## Hornsea Project Three Offshore Wind Farm

Applicant's comments on Written Representations and  
Responses submitted by Interested Parties at Deadline 6

Date: 14<sup>th</sup> March 2019

Figure 1: Large Shallow Inlets and Bays Annex I feature of the Wash and North Norfolk Coast SAC (from [magic.defra.gov.uk](http://magic.defra.gov.uk)) with Hornsea Three offshore cable corridor

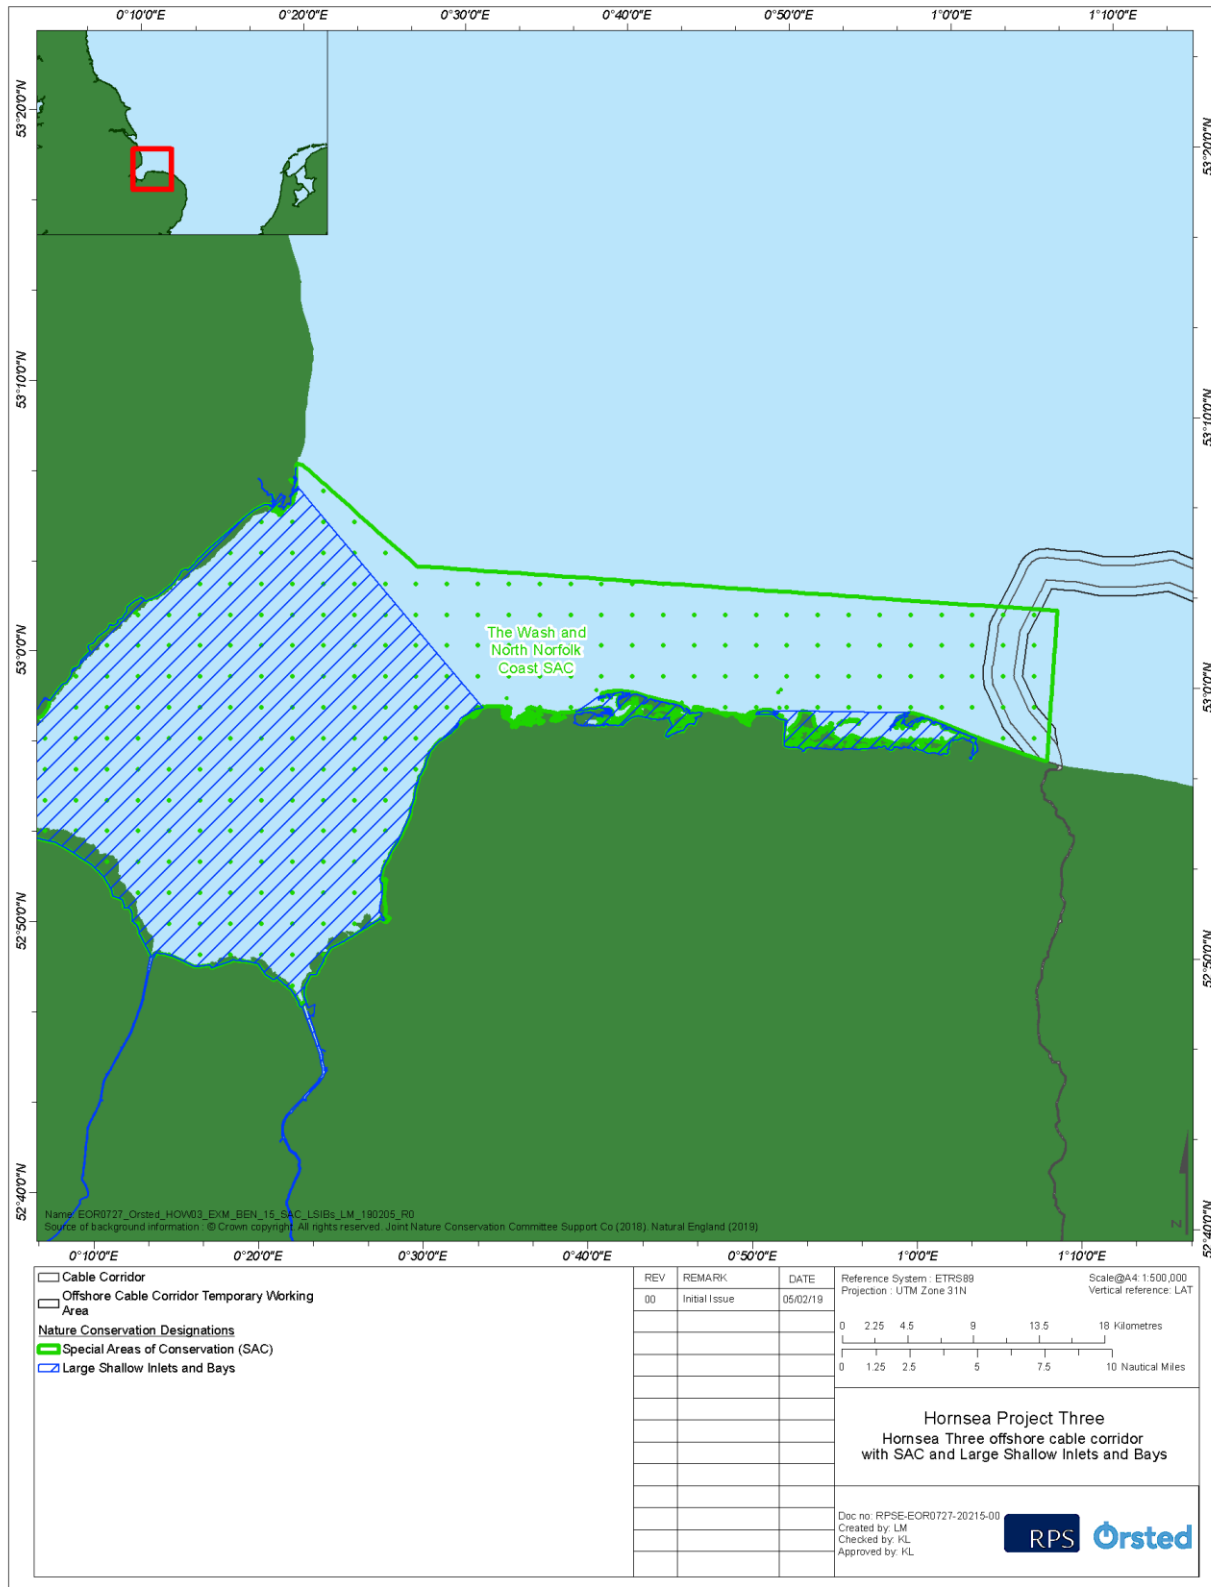
5) Natural England currently considers the impacts from cable protection to be permanent which is not explicit in the document.	<p>As set out in paragraph 3.7 of the Wash and North Norfolk Coast SAC In-combination Assessment, for the purposes of the assessment, cable protection placed for Race Bank would be considered long term temporary (due to the commitment of that project to decommission cable protection at the end of the project lifetime), while for Hornsea Three, the assumption is that cable protection would be left in situ following decommissioning.</p> <p>The Applicant would reiterate the submissions made at Deadline 5 (REP4-012) and Deadline 6 (REP6-018) that the Applicant can commit to decommissioning of cable protection, subject to agreement from regulatory and nature conservation bodies at that time.</p>

6) There remains some doubt in relation to the 25% additional cable protection included as replenishment and how that has been incorporated in the incombination assessment	<p>The in-combination assessment focusses primarily on habitat loss effects associated with cable protection. The maximum design scenario for the area of seabed affected by cable protection (and therefore the area/proportion of Annex I features) includes consideration of replenishment of cable protection, which would not affect a greater footprint than that considered within the maximum design scenario.</p>
